ENCLOSURE 1

Requested Additional Information Pertaining to SCE's Submittal
on Dedicated Shutdown System for Fire Protection
at SONGS 1 (Docket No. 50-206)

FIGURE 3-1 - SYSTEM SCHEMATIC

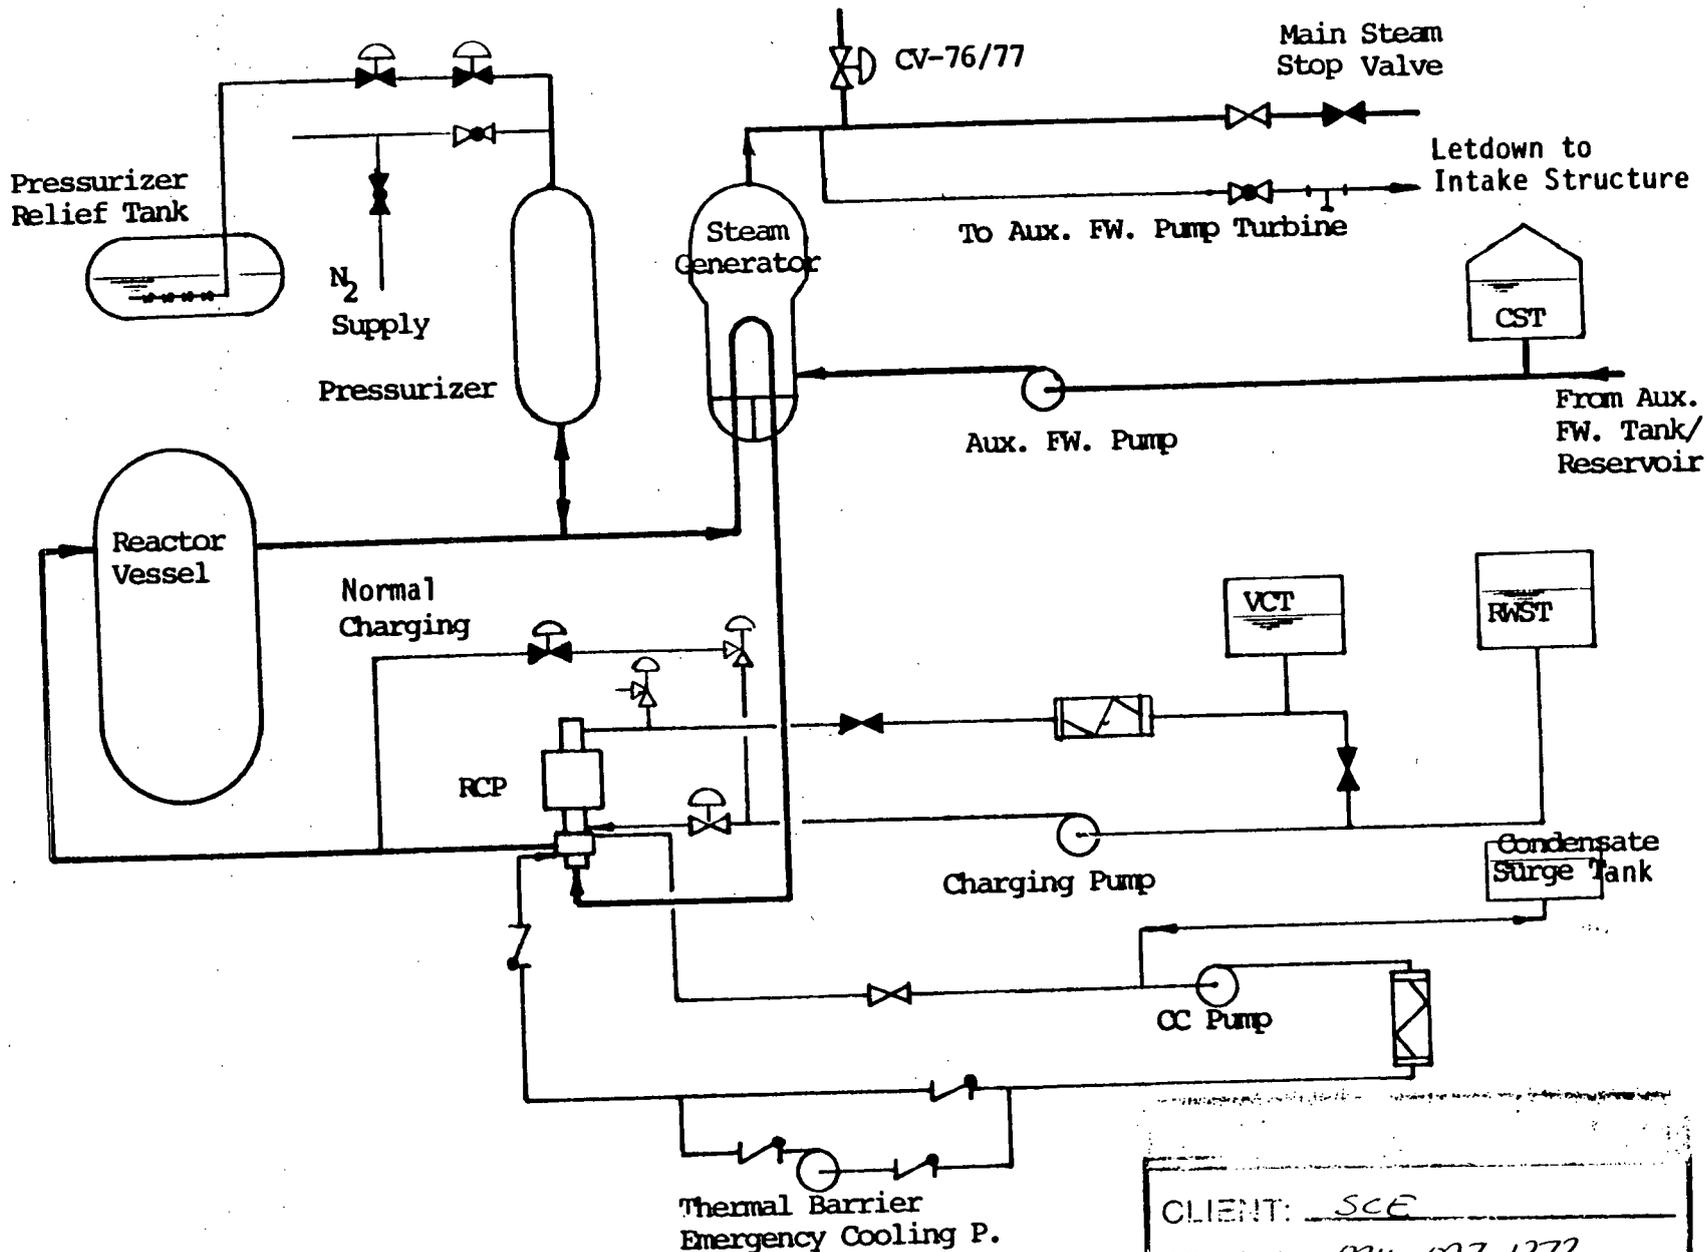
- Q10. With regard to Figure 3-1 of Enclosure 1, provide the following:
- Q10.a Mark CV-113 and the existing manual isolation valve referred to on page 7 of Enclosure 1. Clarify whether the manual isolation valve referred above is the 3"-600-129 manual turbine isolation valve referred on page 17 of Enclosure 1?

- From either of these outfall points, the water is discharged to the ocean.
- Q10.c On page 9 of Enclosure 1, the motor-operated supply valves to the charging pump suction header are identified as LCV-1100 C and D. However, in Figure 3-1, these are identified as LCV-1100 B and D. Which is correct?

Q10.d On page 16, the AFW system flow control valves are identified as FCV-2300, 2301, 3300, and 3301. However in Figure 3-1, these are identified as FCV-3200, 3201, 3300, and 3301. Which is correct?

Q14.c Figure 3-1 shows the valve CV-530 in series with the pressurizer PORV CV-546; also the valve CV-545 is in series with the block valve CV-531. What are the functions of these valves CV-531 and CV-545? Will they also be used in the shutdown procedures?

- R10.c The RWST supply to the charging pump header isolation valves are LCV-1100B and LCV-1100D. Figure 3-1 is correct.

R10.d The AFW system flow control valves are FCV-2300, -2301, -3300, and -3301. Page 16 of Enclosure 1 (of our April 24, 1984 submittal) is correct.

R14.c CV-545 and CV-546 are the pressurizer power-operated relief valves (PORV). They operate to provide overpressure protection to the RCS. As part of the DS system, CV-546 is used to accelerate the rate of RCS depressurization when needed to maintain the system within the desired depressurization envelope. CV-545 is not used.

CV-530 and CV-531 are pressurizer PORV block valves. CV-530 is in series upstream of CV-546; CV-531 is in series upstream of CV-545. (Figure 3-1 of Enclosure 1 shows the valves incorrectly.) The block valves are provided as a means of isolating flow from the pressurizer in the event the respective PORV failed to close. As part of the DS system, CV-530 is used as a means of blocking CV-546. CV-545 is not used.
